## FINAL DRAINAGE REPORT

### BENT GRASS RESIDENTIAL SUBDIVISION

FILING NO. 2 **Preliminary Drainage Report.**  
(~~SF-19-014~~) **EGP-19-005**

#### Engineering Review

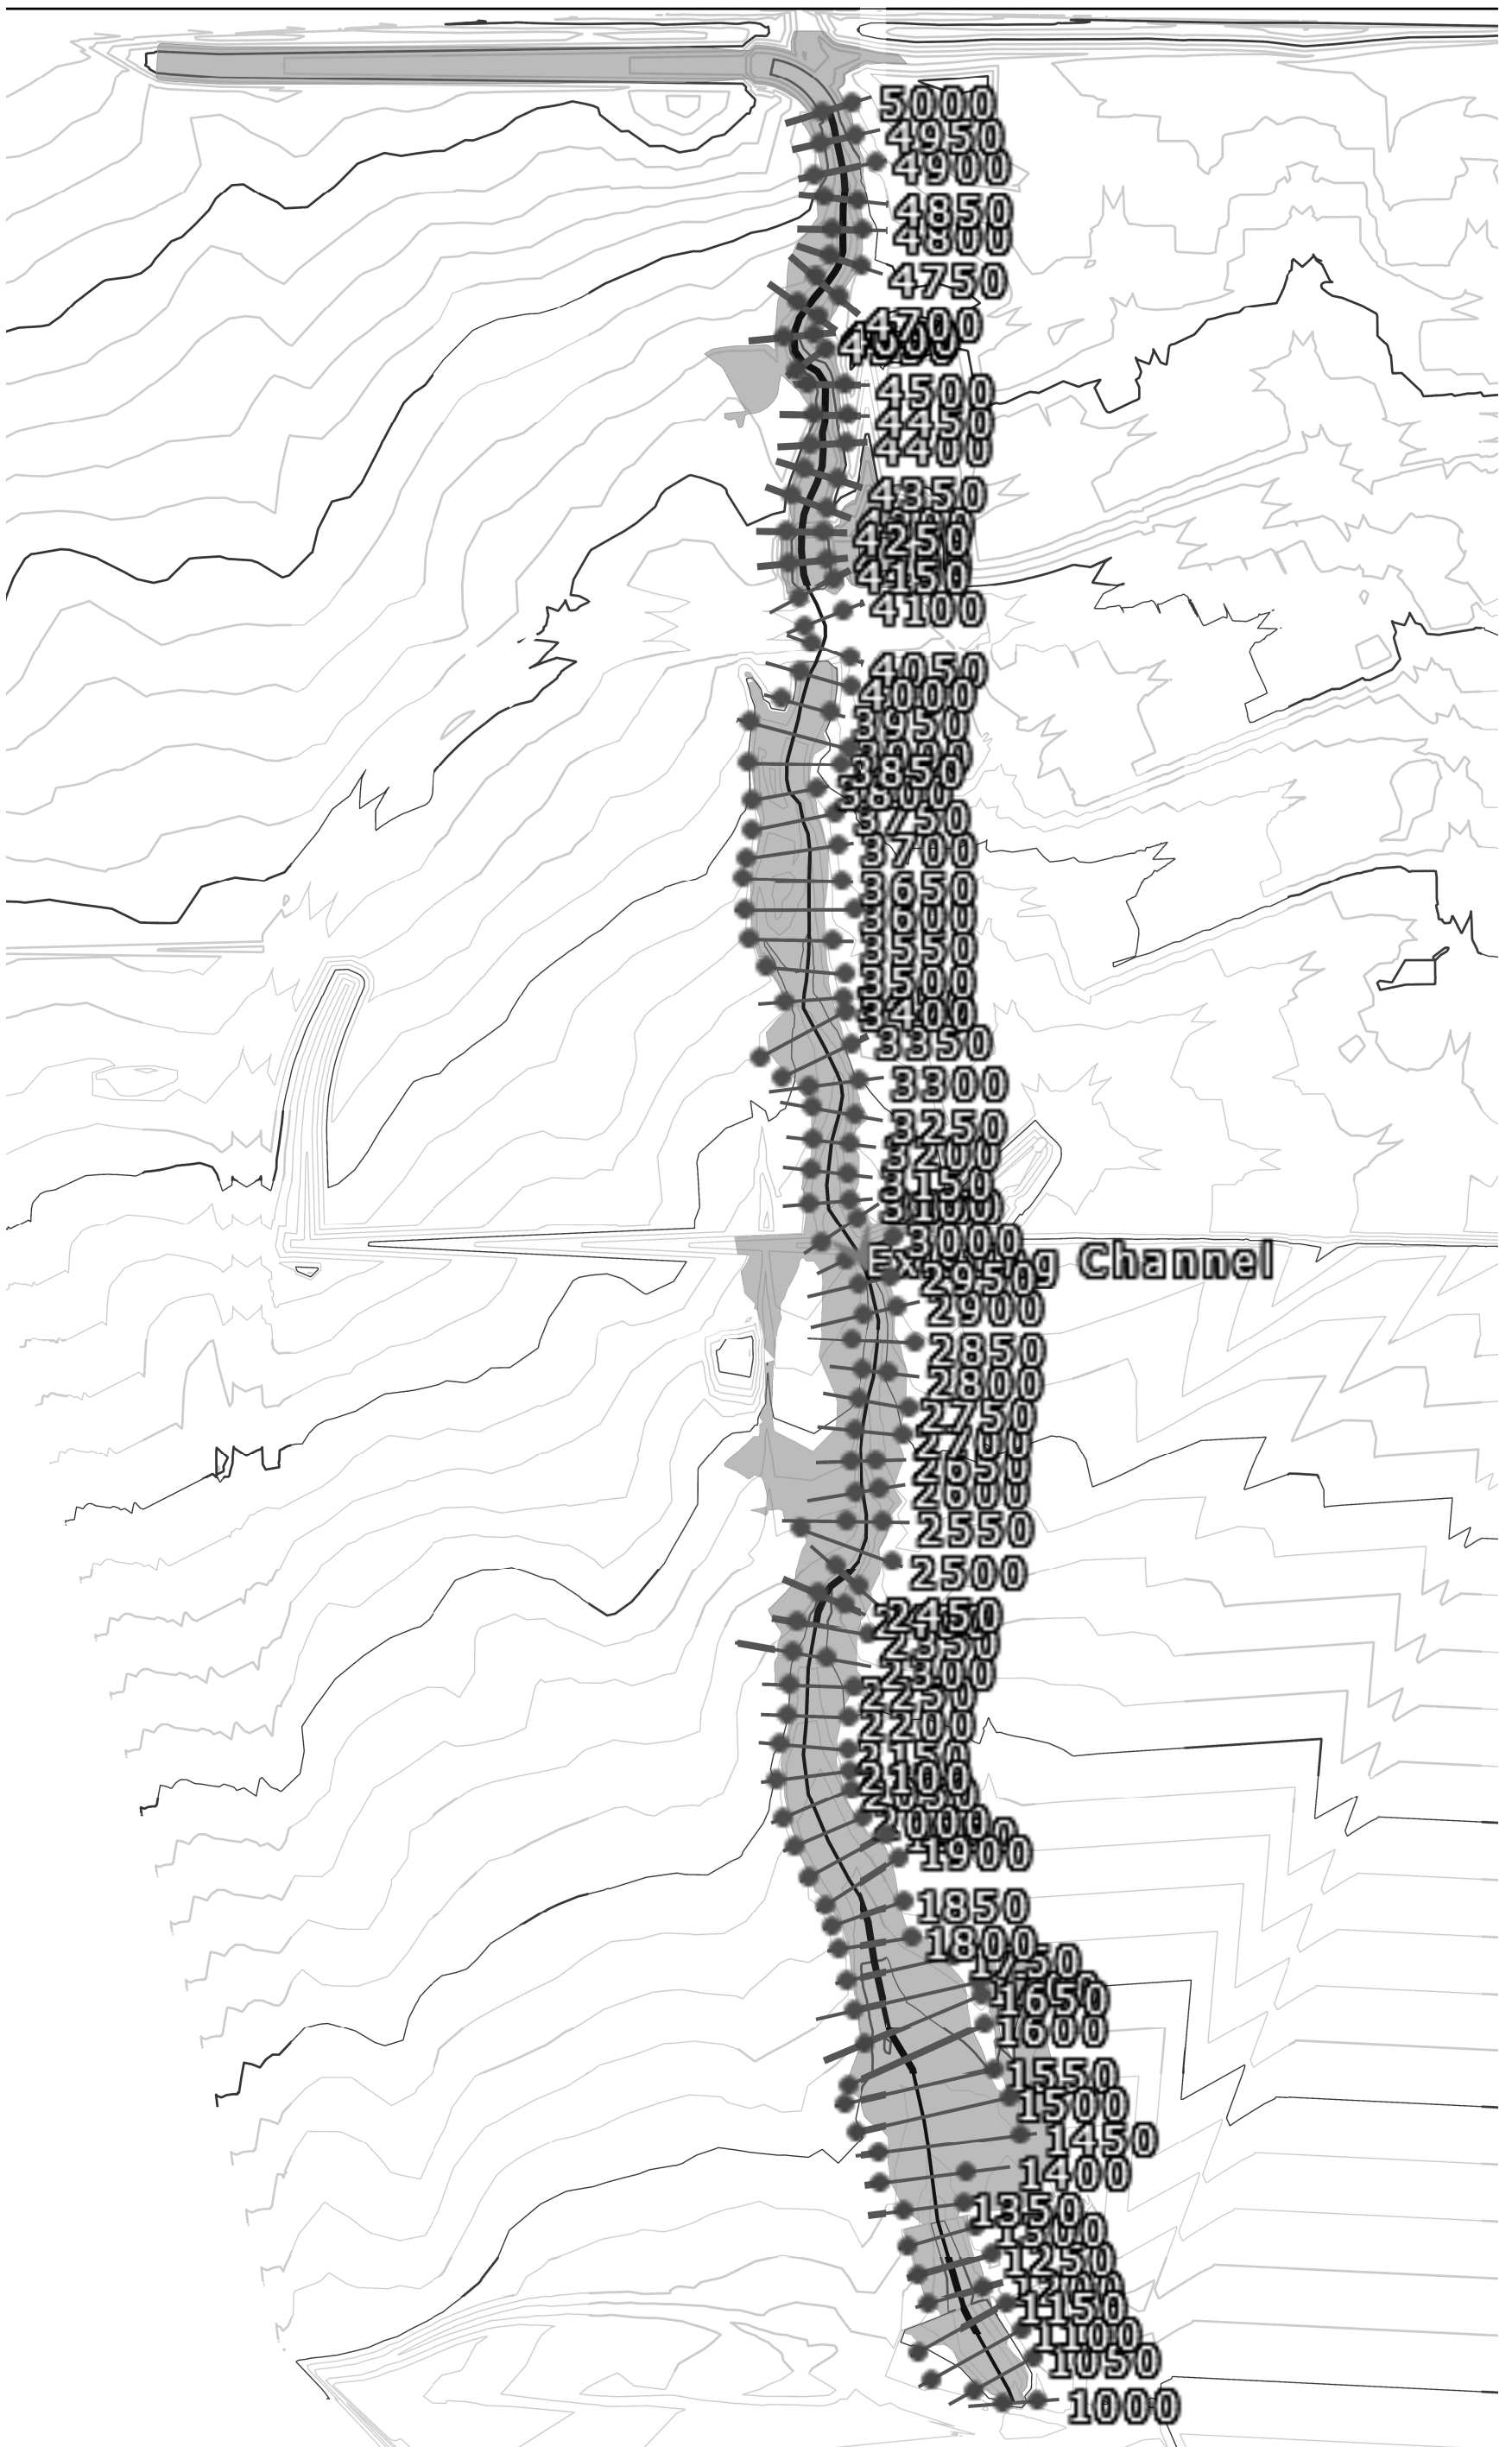
This proposed Swale is obviously erosive and will probably need to be a pipe or something else for these velocities.
